Subject Property:
157 Abbott Street

Application:
Development Variance Permit PL2019-8636

Date: April 21, 2020 **File No:** 2019 PRJ-124
To: Donny van Dyk, Chief Administrative Officer
From: Michael Hodges, Development Infrastructure Manager
Address: 157 Abbott Street
Subject: Development Variance Permit PL2019-8636

Re: VanAbbott Holdings Development (Abbott St-Van Horne St Lane) Design Review

Attachment B – Proposed design drawings

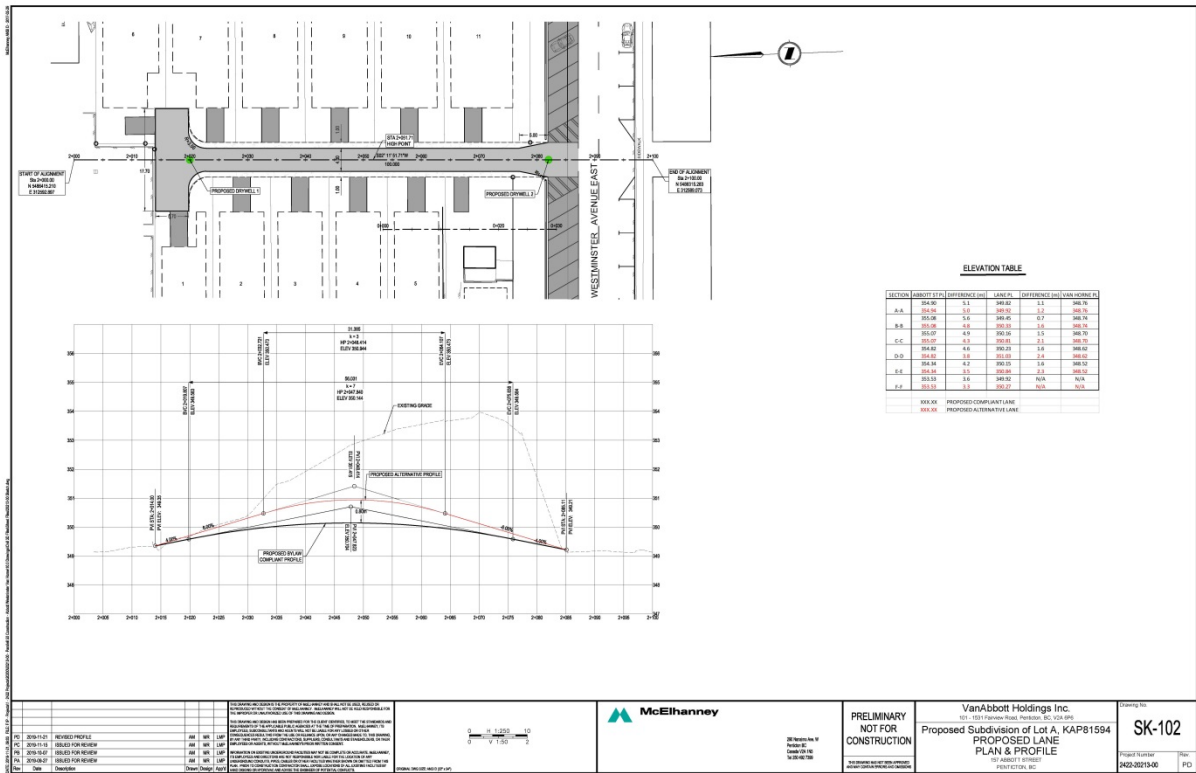
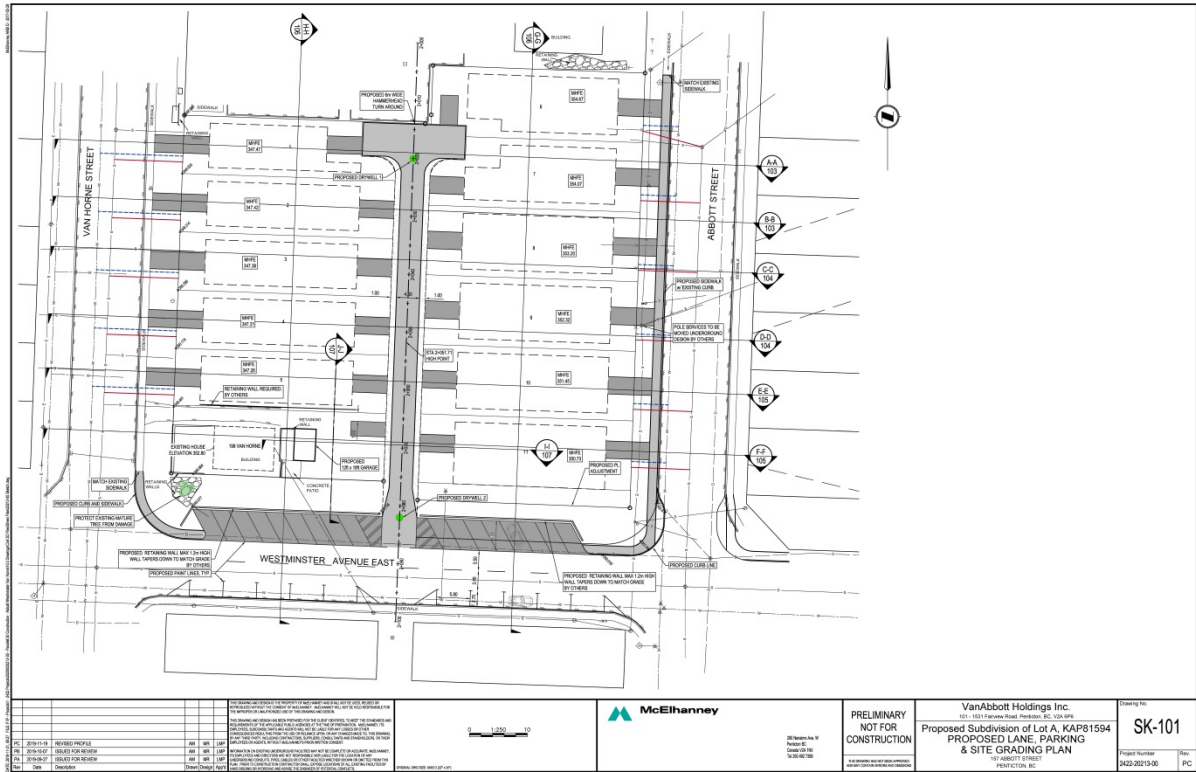
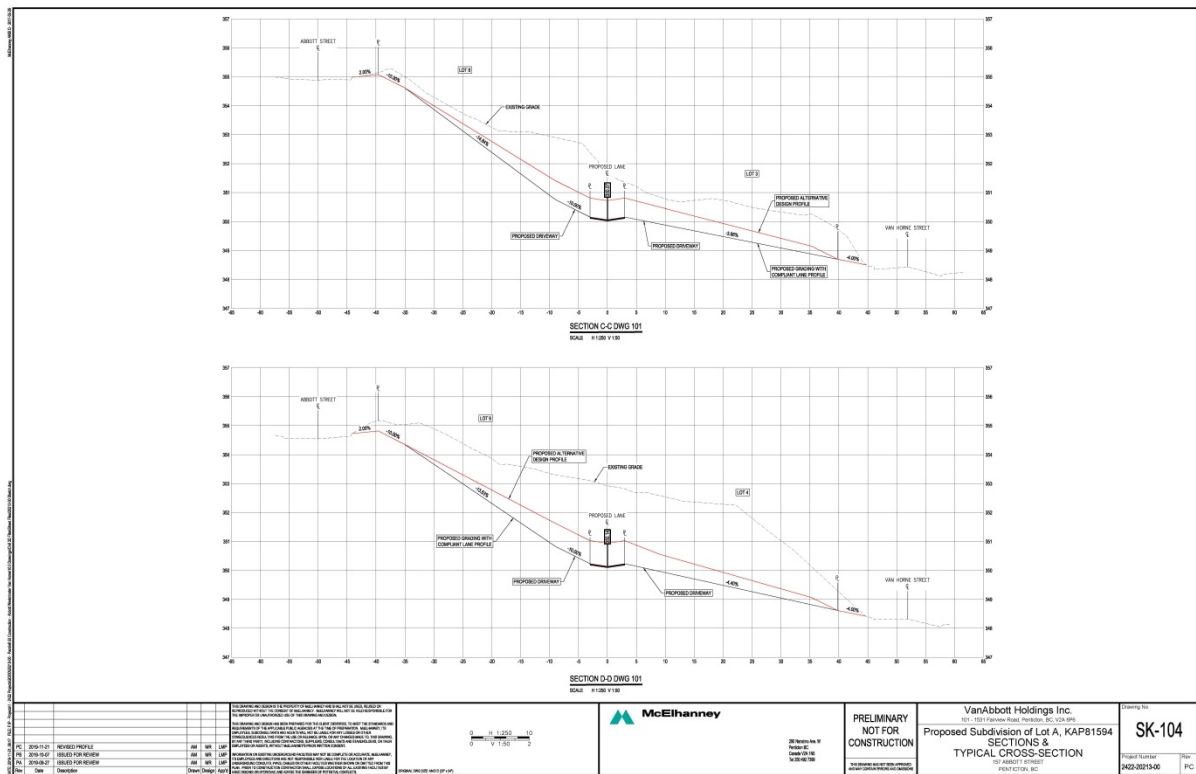
The applicant has provided design drawings showing both the proposed lane with the variance and the Bylaw-compliant lane to illustrate the differences between the two options. These drawings are found in attachment B.

Staff's review of the proposed design concludes that constructing a Bylaw-compliant lane is no more onerous than constructing a lane with the proposed variance. Staff's assessment is that the variance request is not based on technical design or construction constraints, but rather the preference of the developer to achieve an outcome different to the Bylaw.

The applicant has stated that the change to the lane design will eliminate the need for future retaining wall variances, and that such variances will be required if the lane is constructed in accordance with the Bylaw. The drawings provided by the applicant, however, do not confirm this conclusion, and in staff's assessment of the drawings, construction of a Bylaw-compliant lane does not increase the required retaining wall variances.

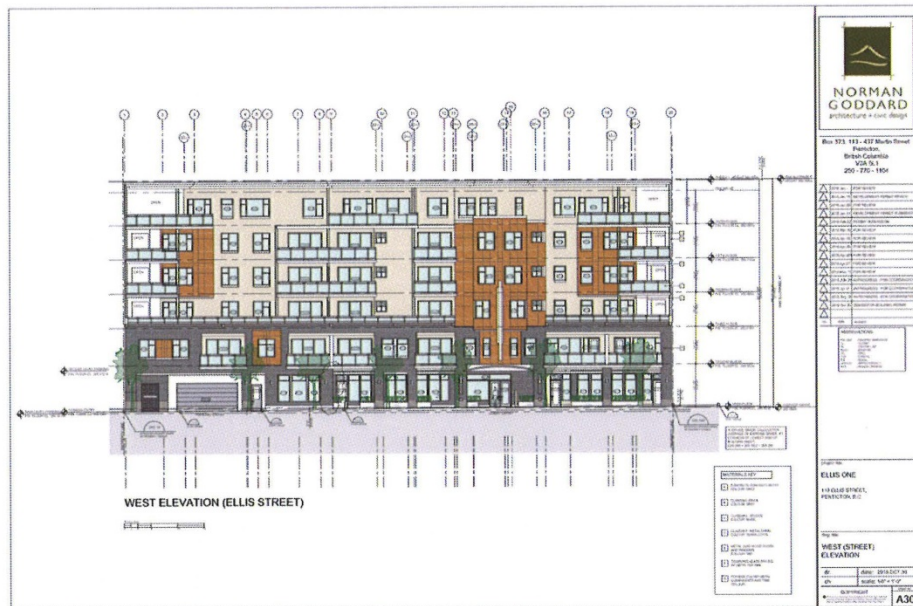
In response to the "Ellis One (Ellis Street-Van Horne Street Lane) Lane Design Review" performed by Peter A. Truch (Dated March 25, 2019), Ecora Engineering and Resource Group Ltd (Ecora) would like to address the three (3) concerns identified: Vertical Curve Length, Vertical % Grade of the area North of the paved lane, and Parkade Transition from the Lane into the structure.

In the civil design drawings dated March 15, 2019 the length of vertical curve is 13m with a corresponding K-Value of 1.00. Mr. Truch has recommended increasing this curve length to 20m. Please see attached drawing showing this revision.
